UNT SYSTEM™

DATE: February 28, 2025
TO: Potential Respondents
FROM: Carrie Stoeckert—Construction Contract Expeditor III
SUBJECT: Addendum #1
RFQ752-25-1004CS
Chilton Hall 111 Renovation

ADDENDUM NO. 01

PROJECT: Chilton Hall Level 1 Renovation
HE0569.240100

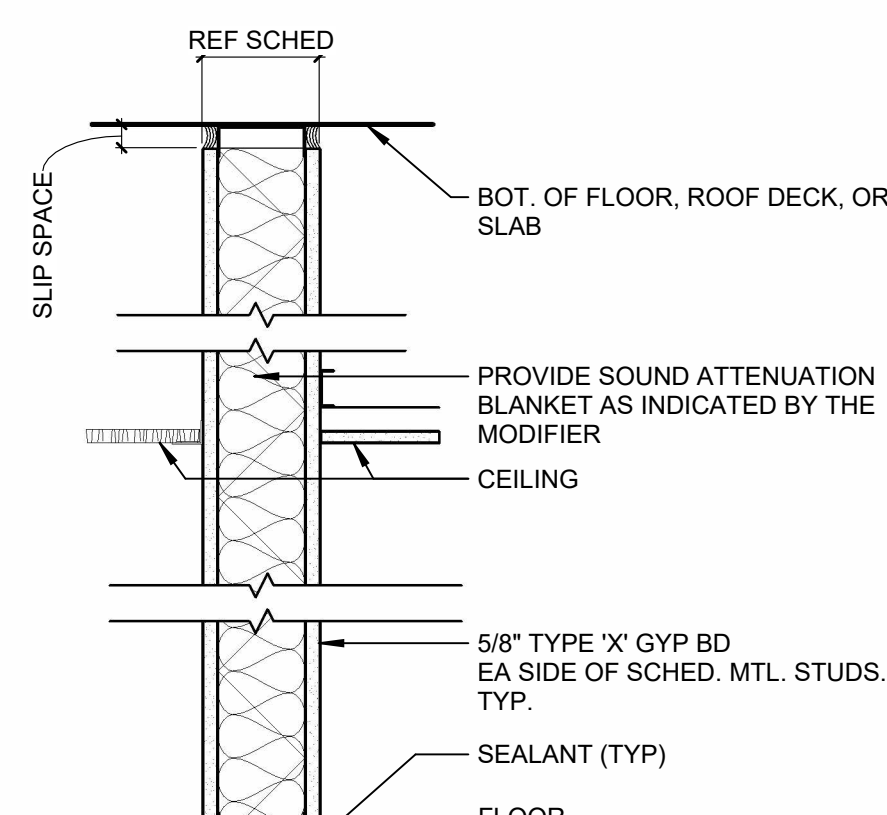
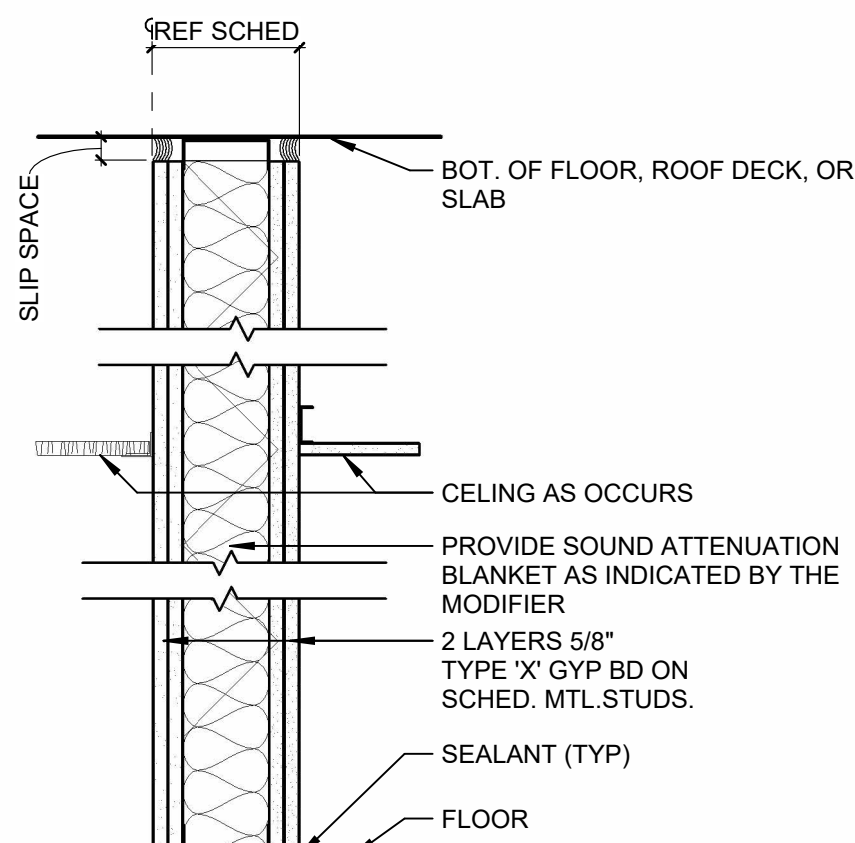
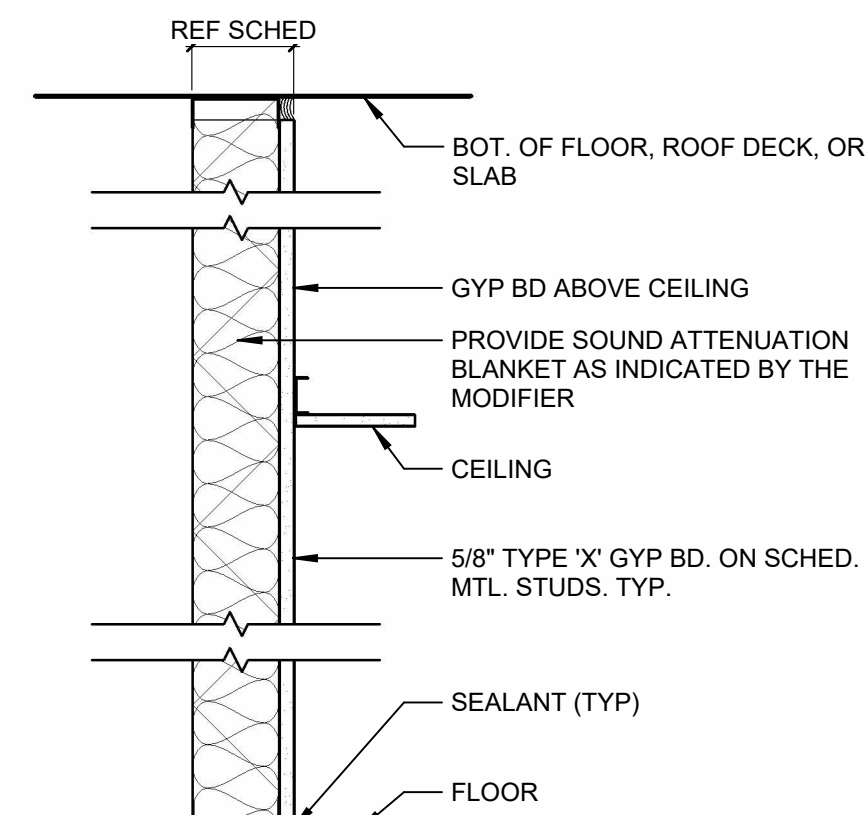
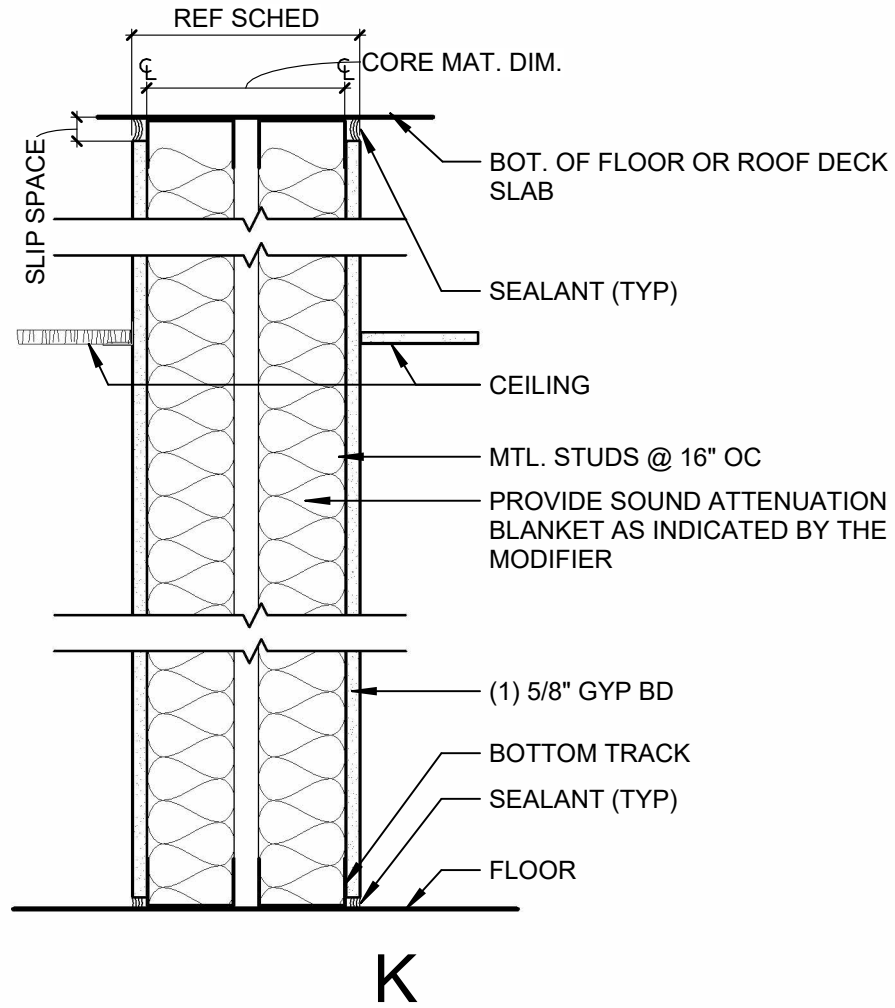
1.5	<u>A005 PARTITION DETAILS AND NOTES:</u> <ol style="list-style-type: none">A. Changed Partition Type K3a1 to K3a.B. Added A3a1 to “WALL SCHEDULE”.
1.6	<u>AD101 DEMOLITION LEVEL 1</u> <ol style="list-style-type: none">A. Changed graphics to show Conference Room wall demo.

A101

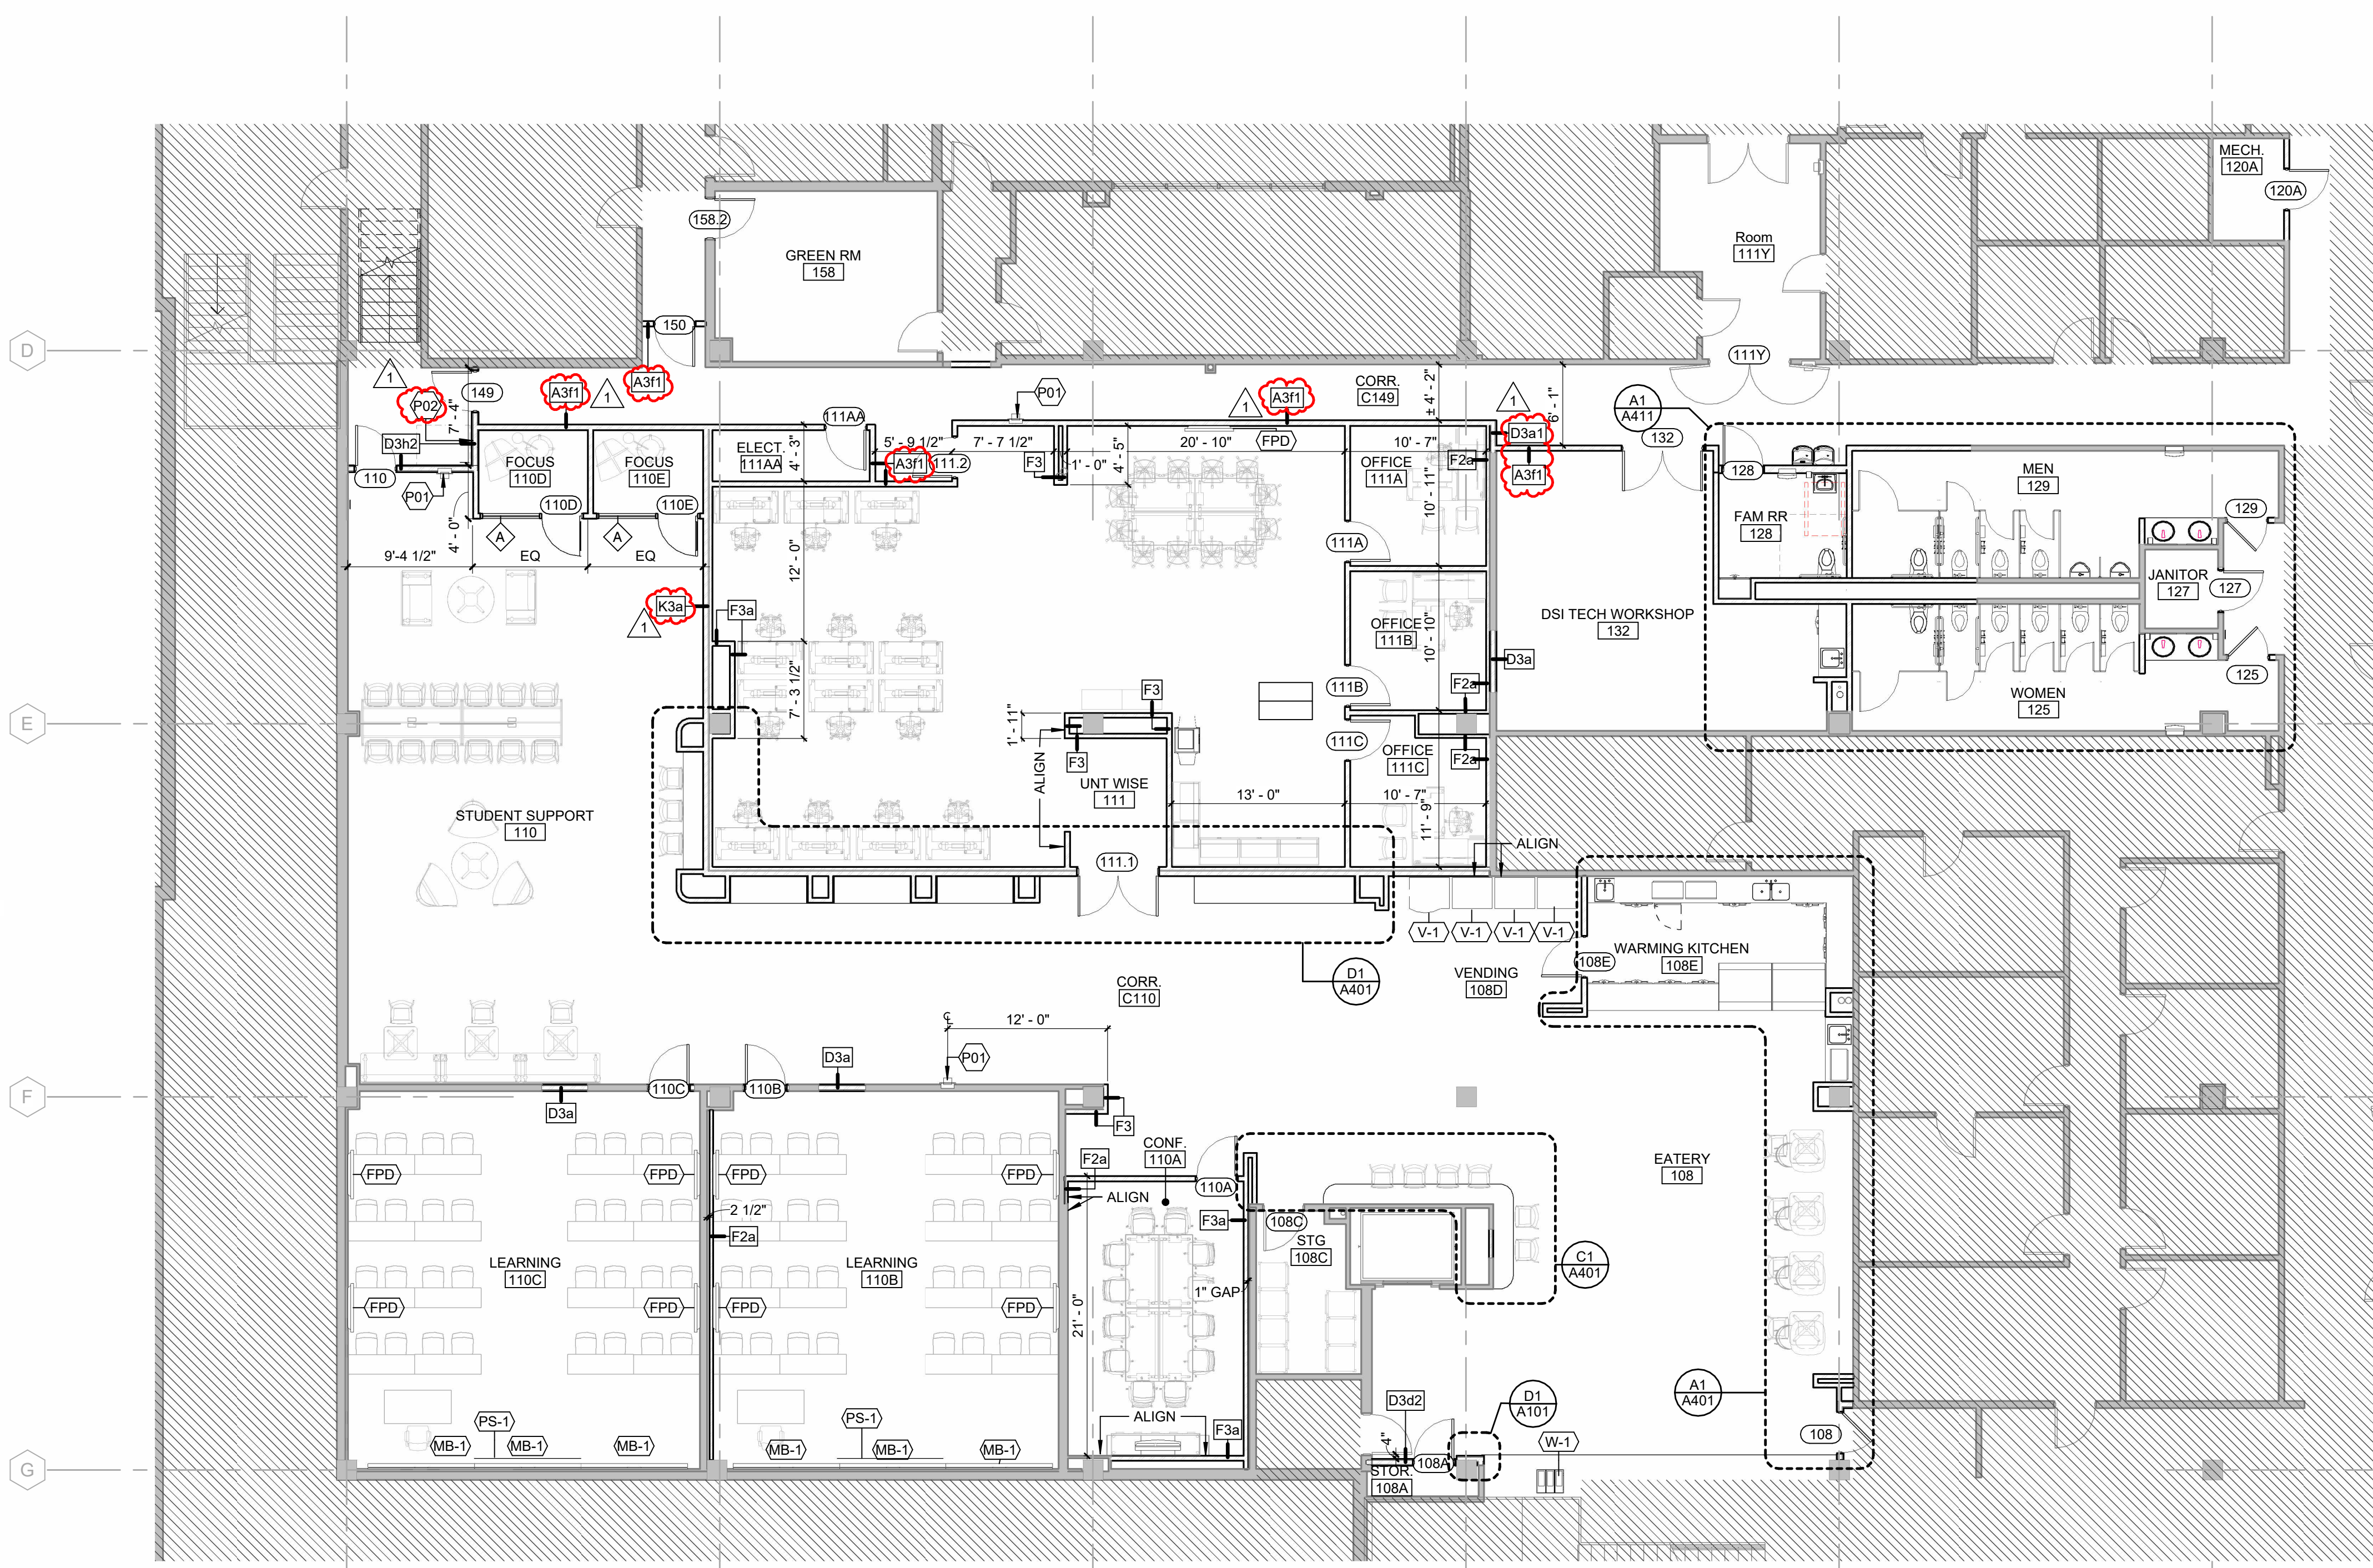
ITEM	DETAIL
1.7	<u>A101 FLOOR PLAN – LEVEL 1</u> A. Adjusted door tags. B. Revised partition tag.
1.8	<u>A401 ENLARGED PLANS</u> A. Revised partition tag.

LEVEL 1 FLOOR PLAN -
DEMO MECHANICAL

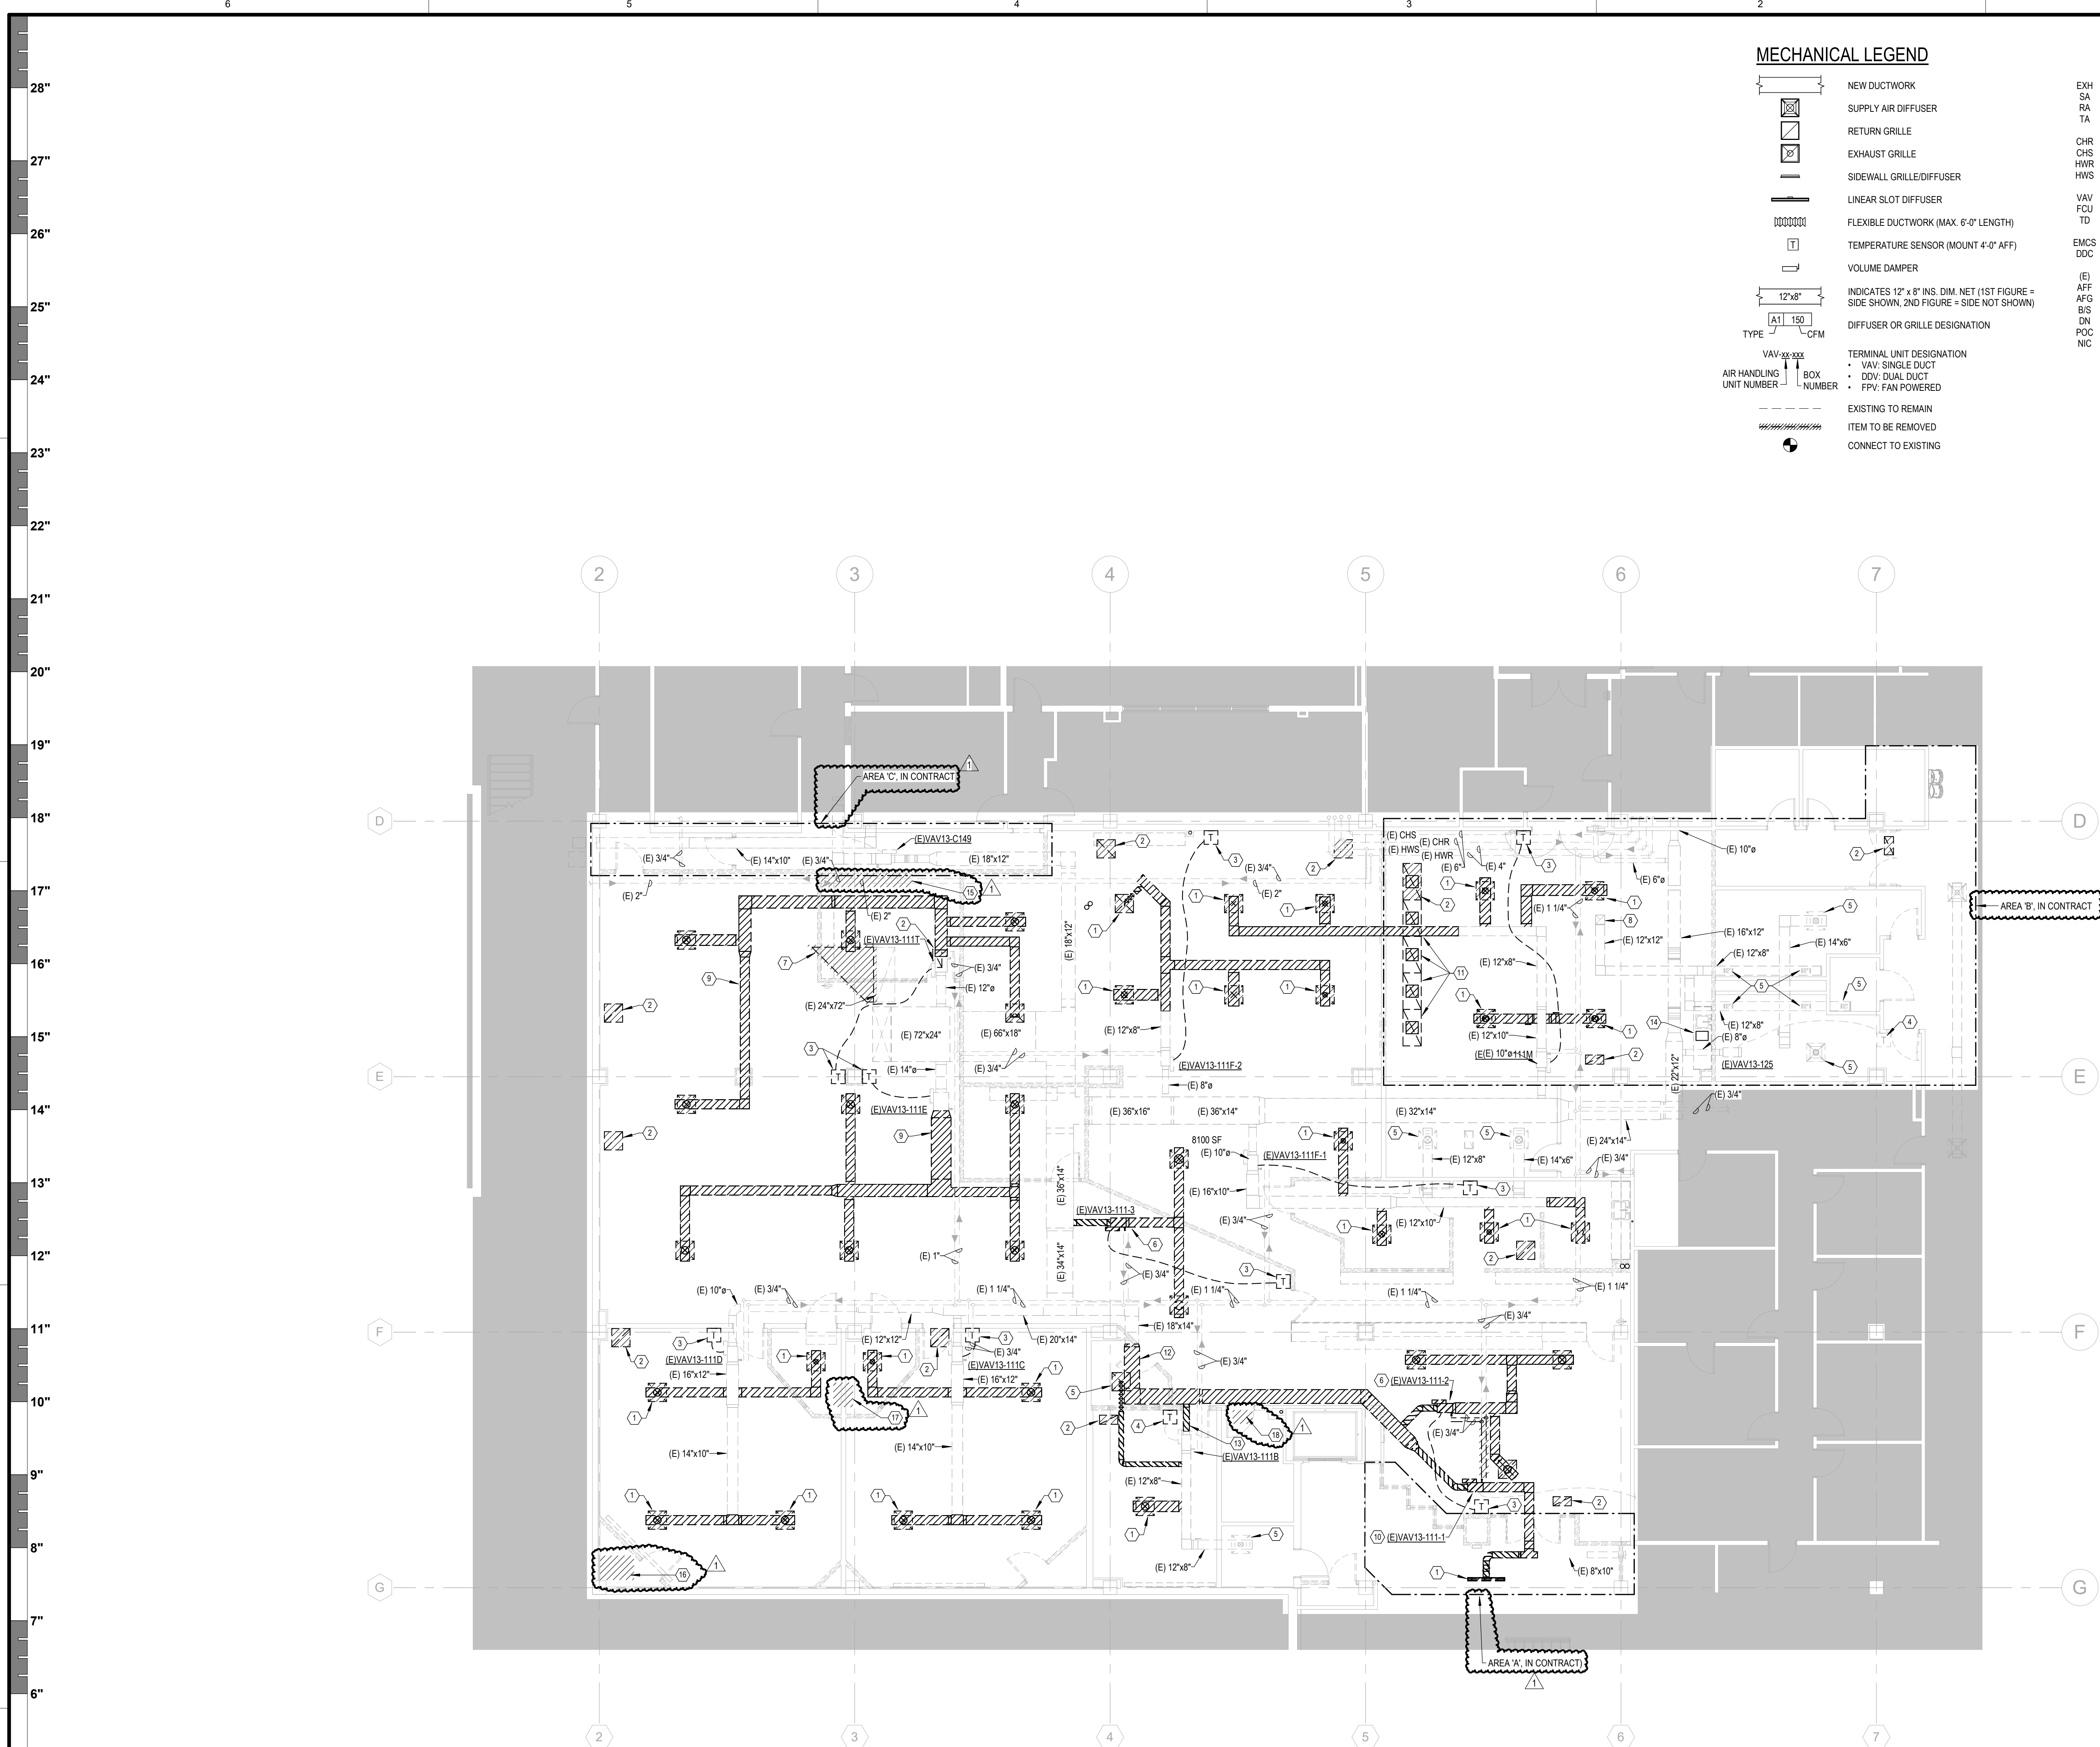
1.22	<u>MD101</u>
	A. UPDATED: Area A, B, & C note on the floor plan. B. ADDED: Location of existing abandoned equipment to be removed. C. ADDED: Notes by symbol #15, #16, #17, and #18.
